DRAINAGE REPORT
FOR
WASHINGTON BUSINESS PARK

Weiss-Hines Engineering, Inc.
1100-B Alvarado N.E.
Albuquerque, NM 87110

May, 1986

FIGURE 1

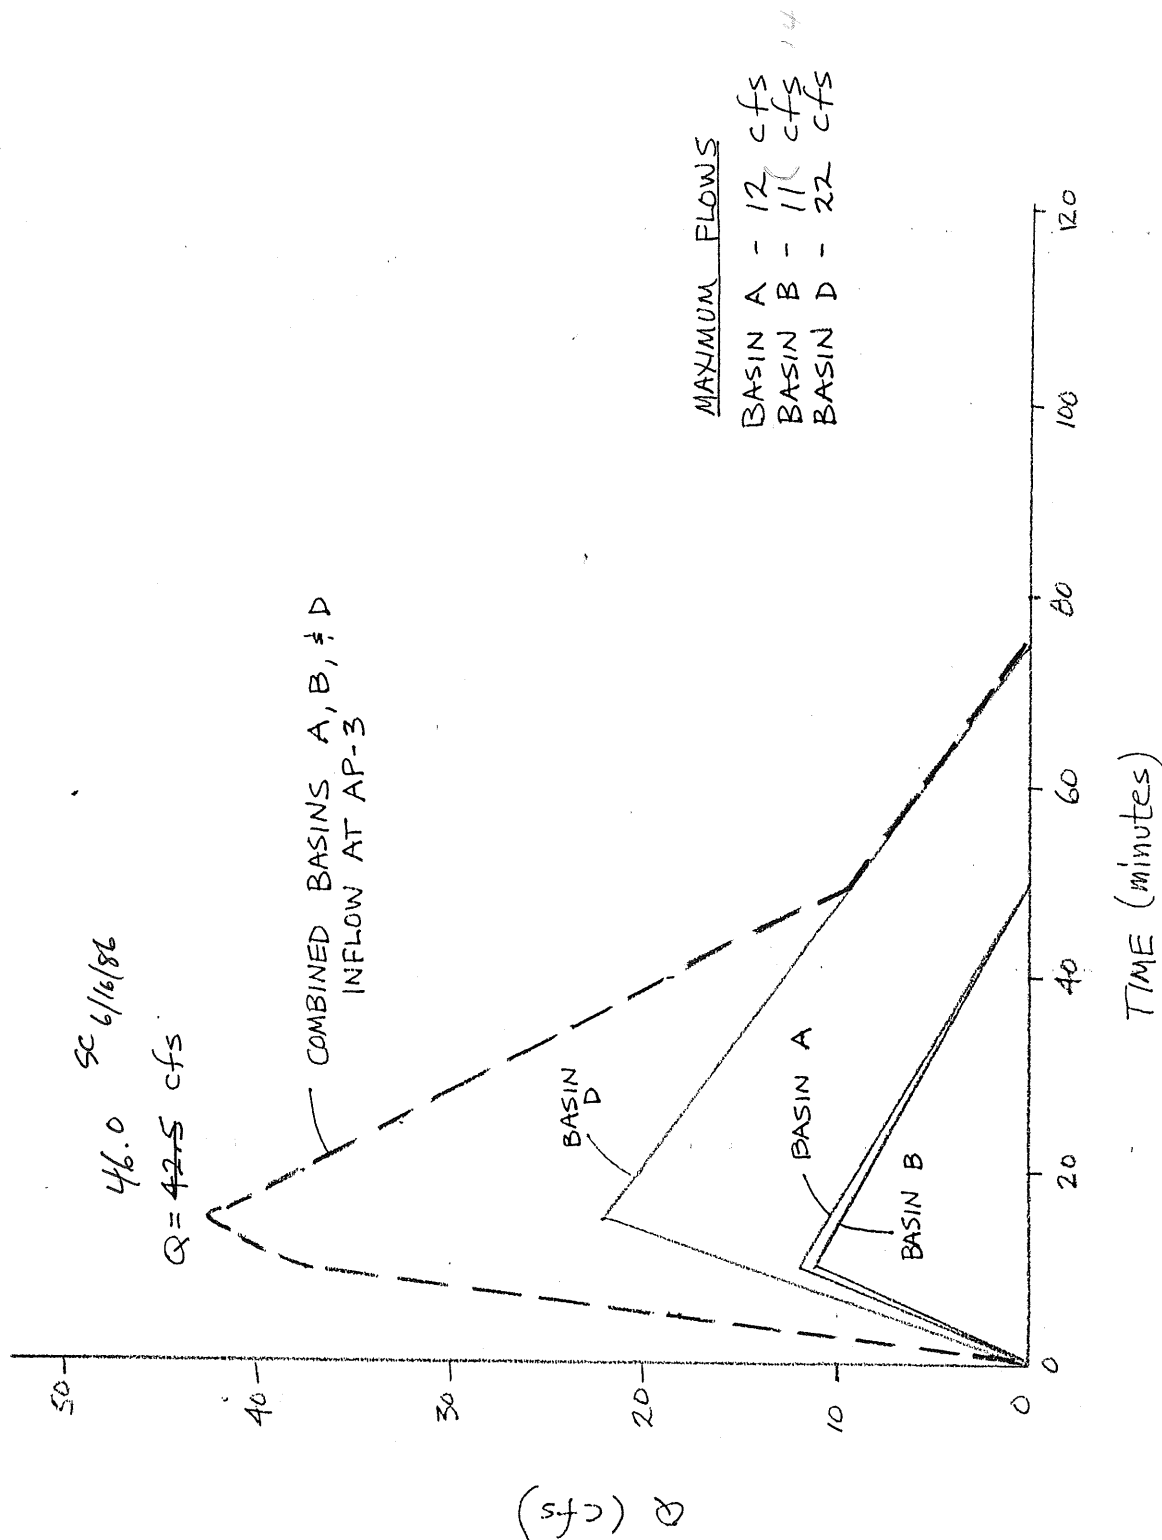
Analysis Point 2 - Runoff from Basins 'A' and 'B' combine at AP-2. The combined hydrographs at AP-2 (Figure 1) indicate a peak discharge rate of ~~23~~ cfs. These flows continue west to AP-3. *26 SC 6/16/86*

Analysis Point 3 - The combined runoff from Basins 'A', 'B', and 'D' discharge through AP-3 at a maximum rate of ~~43~~ cfs (see Figure 1). These flows then travel south to AP-4. *46 SC 6/16/86*

FIGURE 2

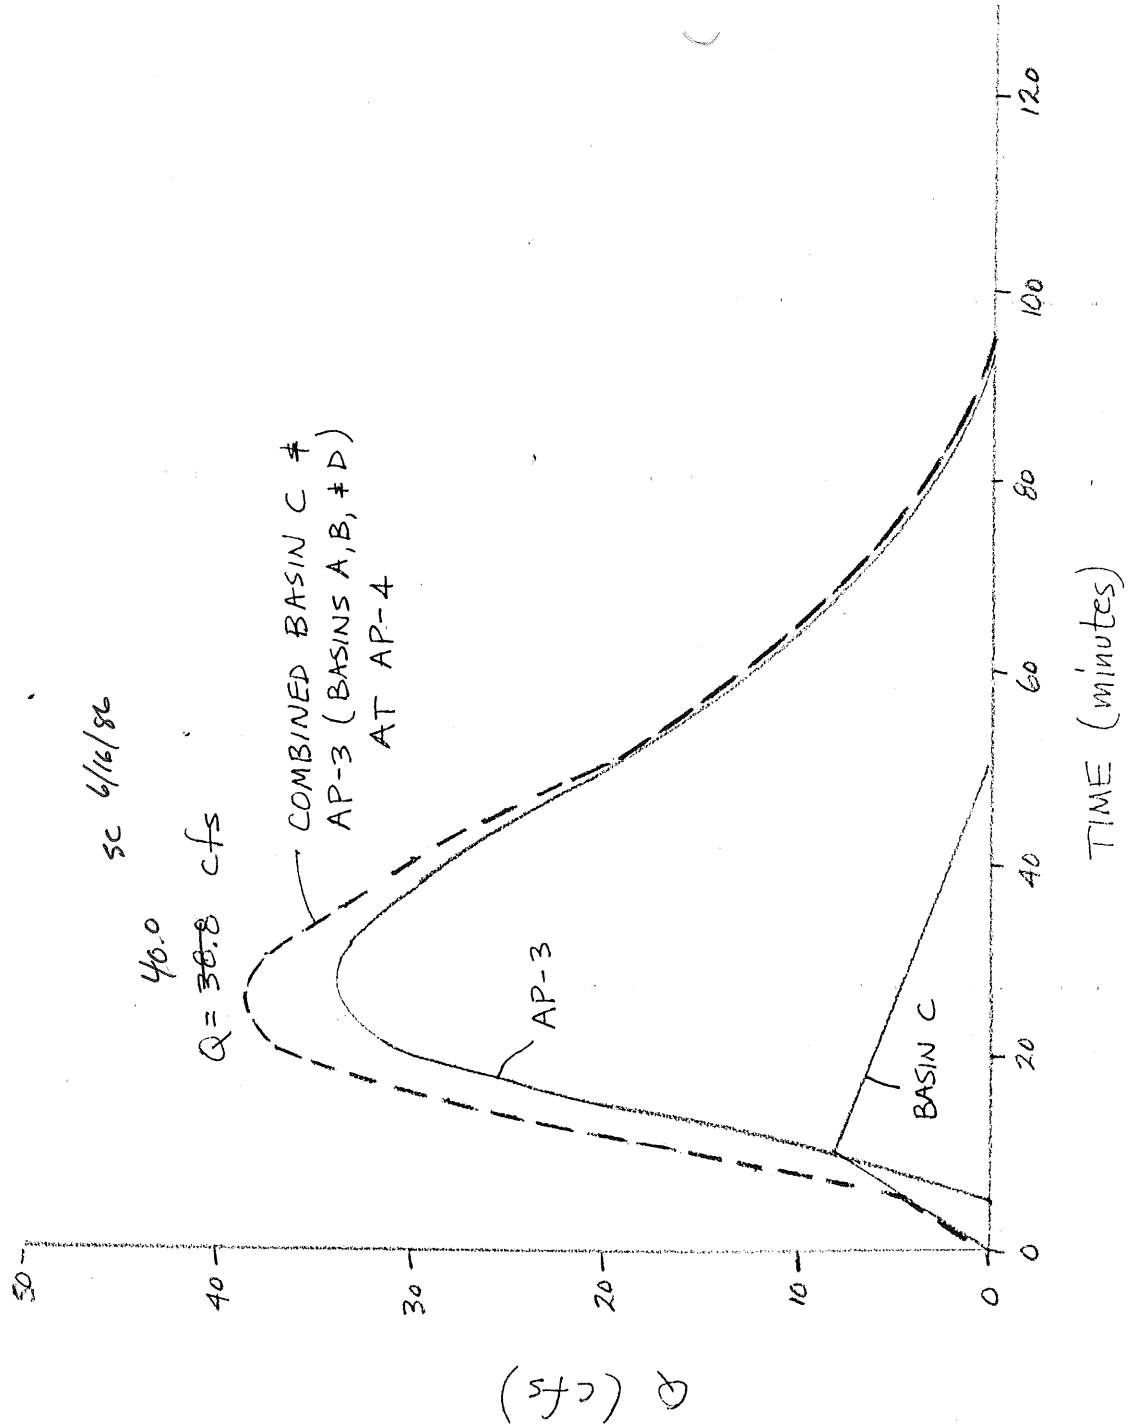
Analysis Point 4 - Discharges from Basins 'A', 'B', and 'D' (AP-3) combine with those in Basin 'C' and are routed in Swale 'A' southerly to AP-4. These flows discharge at a peak rate of ~~39~~ cfs (see Figure 2). From AP-4, flows discharge into the North Diversion Channel. *40 SC 6/16/86*
